# APPENDIX FF: DESIGN INTEGRITY REPORT

**Pitt Street South Over Station  
Development**

State Significant Development,  
Development Application (SSD DA)

**SMCSWSPS-URB-OSS-PL-REP-000005**

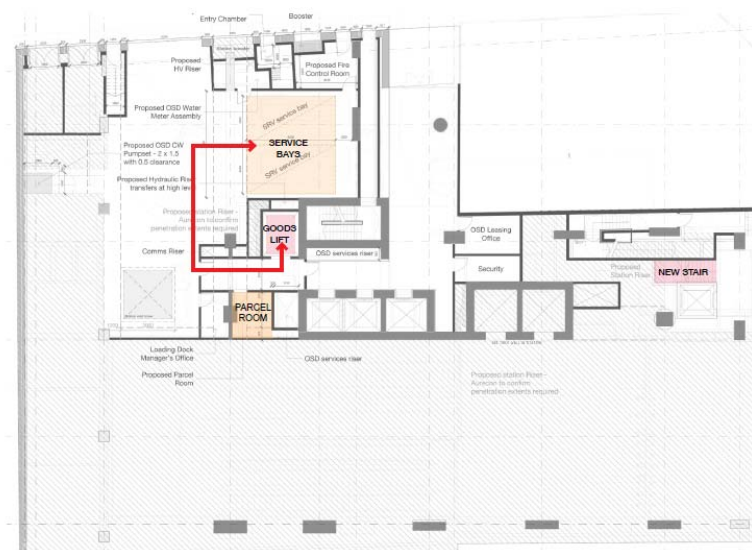
The Panel **requests** that the following be presented at the next meeting:

- Demonstration that the proposed lifts will provide an appropriate level of service to service 227 apartments and other uses.
- Demonstration that the loading dock and service lifts will provide a sufficient level of service.

#### Planning & Passenger Movement

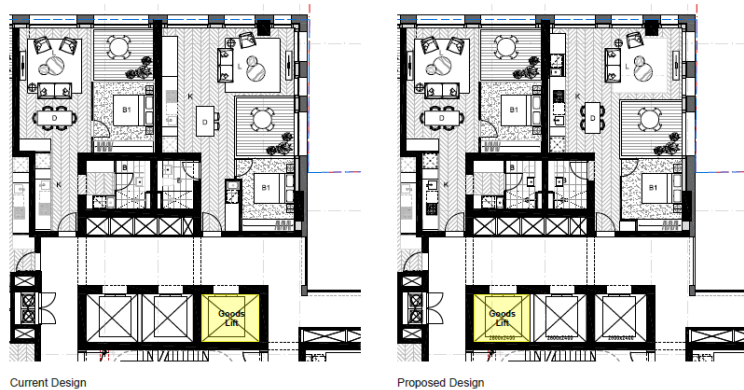
- The Panel supports the proposed lift numbers on the basis of the analysis presented – being 3 passenger and 1 service lift for 227 apartments.
- The Panel raised concerns about the level of service provided by the current arrangement of loading dock and service lift (that requires changing lift at the lobby level). The Panel requested to see alternative configurations bringing the residential service lift closer to the goods lift, or ideally a model that does not require lift change from loading to apartment floors, whilst noting that the client is confident that this model is workable.

- The Panel accepts the design change presented for loading and vertical transport which achieves direct access from the loading dock into a larger residential service lift at the entry level, avoiding the need to transfer between lifts at the upper level.

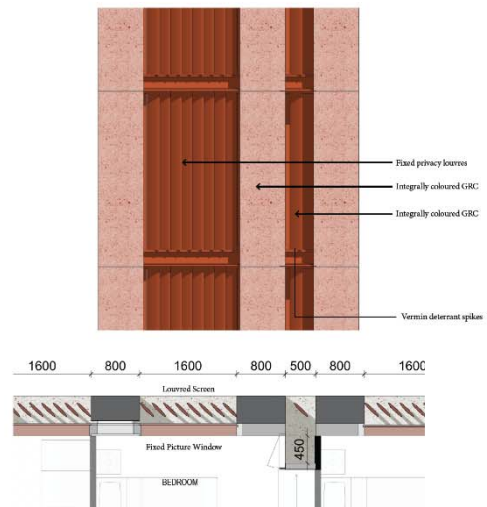
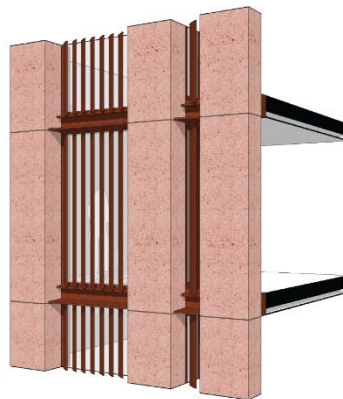
The Panel note that this proposal appears to meet the minimum requirements of the relevant contract design parameters however, the panel raised the following concerns with the presented solution:

- Conflict between safety and cleaning
- Conflict between access to ventilation and acoustic separation

The Panel supports that visual privacy is achieved through the noted vertical louvres to the apartment windows facing the Princeton Apartments.

### South façade ventilation

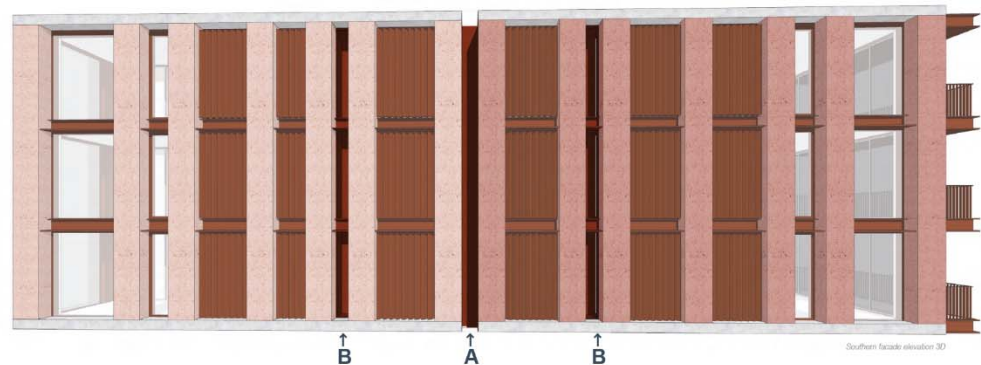
The **Option 2** ventilation strategy was endorsed by the DRP after referral to and consultation with the City of Sydney

- The Panel accepts removal of the vertical blade to the ventilation slot on the south façade (Princeton Apartment interface) noting further development of horizontal ledges to be provided.

Pitt Street Elevation Current and Option 2 and 3

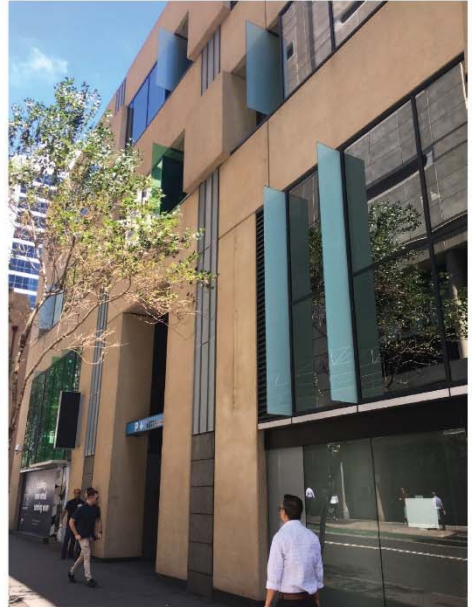
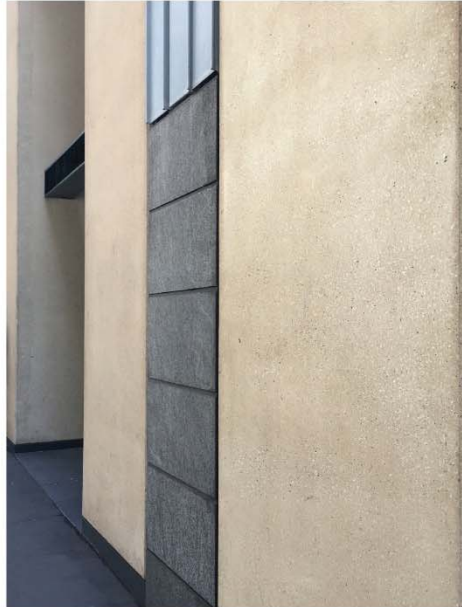
- The Panel recommends considering a different treatment to the precast façade panels at street level in order to provide a richer sense of detail.

- The Panel note that limited options were developed by the design team to introduce detail into the street level precast panels. The Panel acknowledge that mimicking the brick striations/banding is not a suitable response and recommend further investigation be undertaken to test texture and applied finishes to resolve a finer level of design detail, and that additional larger scale samples are developed and request the DRP are invited to review further proposals. (DIT Item 4.01 response)
